NEW SHOP FRONT SLIDER PROFILE NKSDGWP - AB534

January 2019
Technical Bulletin
www.hbs.co.za

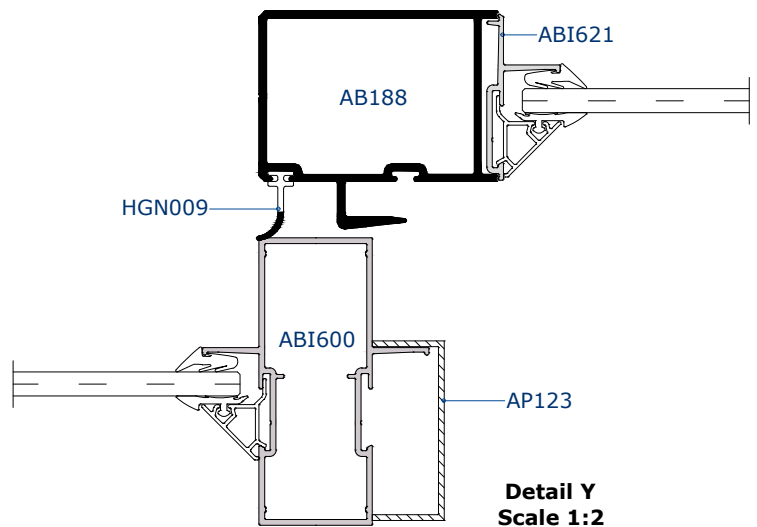
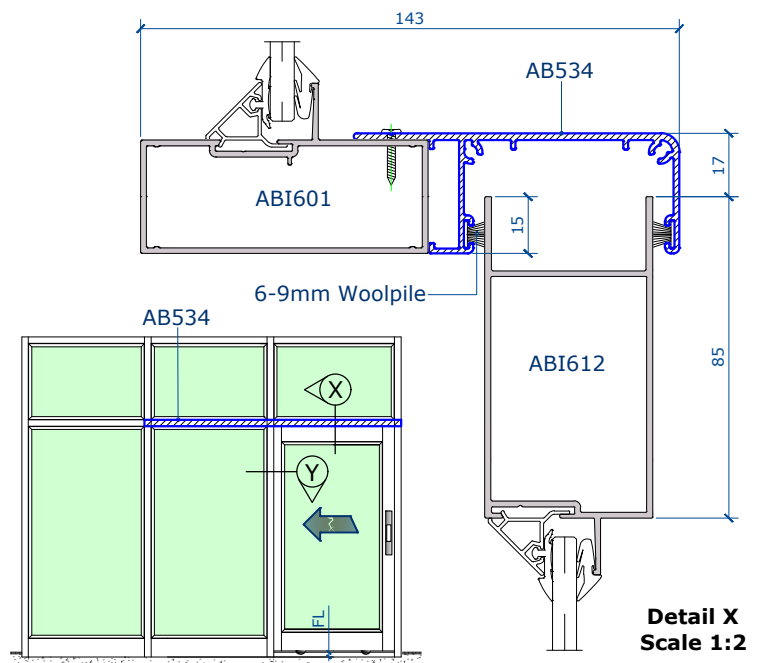
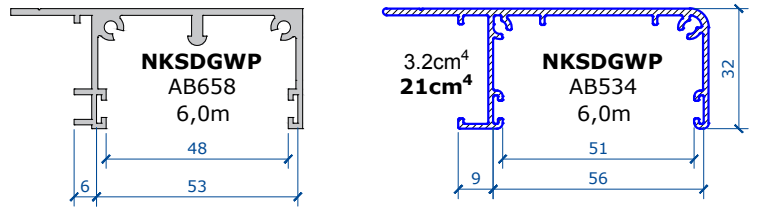
- AB534 is compatible with 21mm Galaxy T-seal (HGN009) for improved weather proofing.
- Increased profile tolerance for use with 6-9mm pile.
- 15% lighter than old profile (AB658).
